State of West Virginia Department of Administration Purchasing Division 2019 Washington Street East Post Office Box 50130 Charleston, WV 25305-0130

Addendum Number:

02

Addendum for the Land Reclamation project: "Cartright Branch Refuse Pile" Project issued to provide and publish the following information as attached.

Item 26: Bat Gate Detail

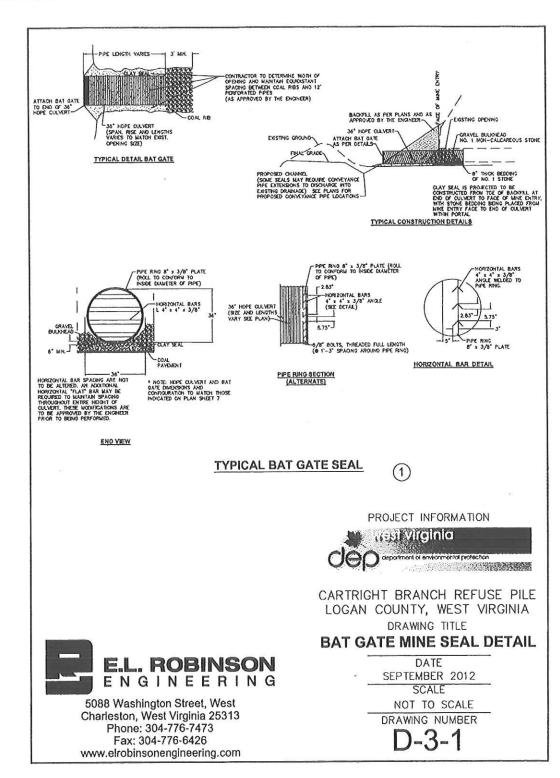
A At the beginning of the PBC, it was erroneously stated that the area we were standing on (at the Jeep) was not part of the site access. However, access to Site 2, (shown on Sheet 4), does start in the area mentioned, which is approximately 100 feet southeast of the existing chain link fence.
- Item 3: Q Is the culvert bat gate detail on Sheet D3 correct?

A No. The correct detail is included in this Addendum as Item 26. This detail is to replace Detail 1 on Sheet D-3.
- Item 4: Q Can the concrete ruins at Dry Seal 1, Sheet 4, be incorporated with the fill? A Yes. This is addressed in section 4.3.4 in the Technical Specifications.
